MFN 08-660

**Subject: Response to Portion of NRC Request for Additional Information Letter No. 66 – Related to ESBWR Design Certification Application – RAI Number 21.6-90**

**NRC RAI 21.6-90**

*Question Summary: Control blade dimensions in full out position.*

Figure 1: ESBWR 1/4 Map, Showing the Placement of the Control Blades and Radial Migration Paths Through the Bypass Spaces

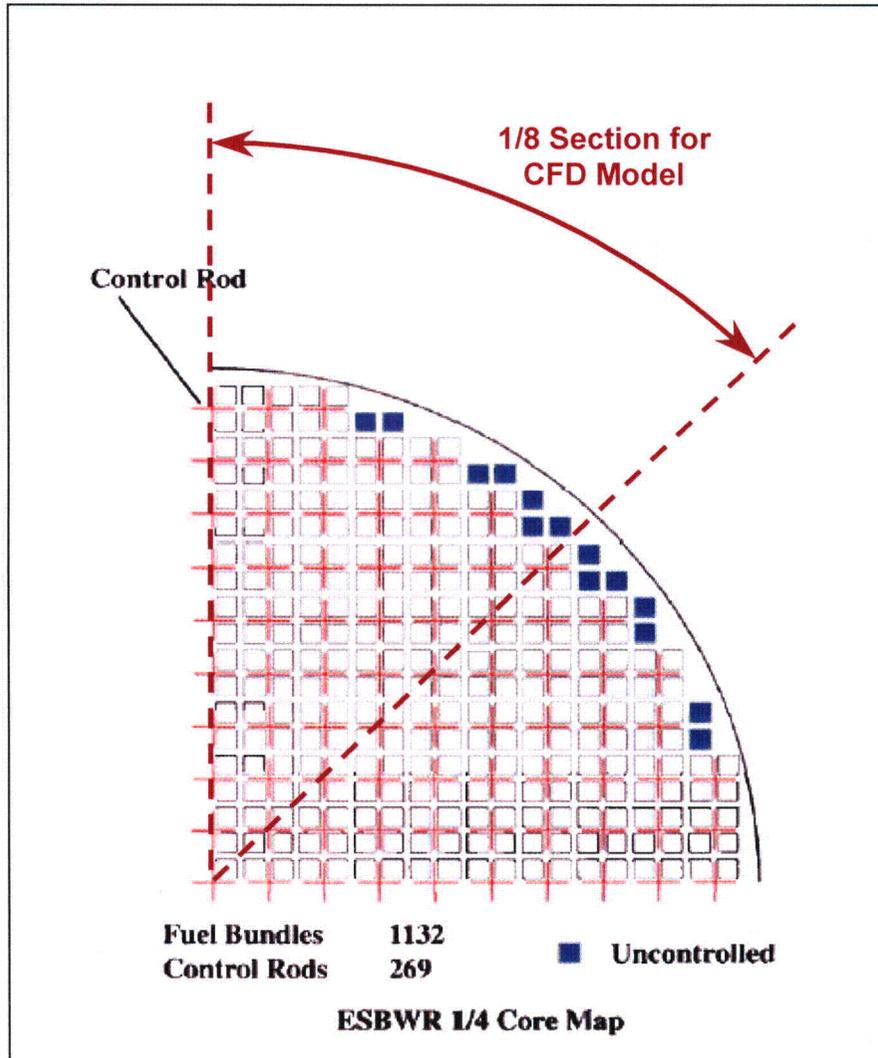
*Reviewer Summary: In an ATWS event, the presence of control blades in the lower bypass will affect the boron distribution. Provide the height of the control blades above the top of the core plate when blades are in the full out position. Discuss how the presence of control blades in the lower bypass affects the boron distribution. If this is not accounted for in the TRACG analyses of an ATWS event, demonstrate that the presence of the control blades does not affect the ATWS analyses.*

The presence of the control blades acts as blockage to the radial migration of boron through the core bypass spaces. Figure 1 shows that alternate unobstructed paths also exist between the control blades through which boron is free to migrate radially through the bypass space lattice.
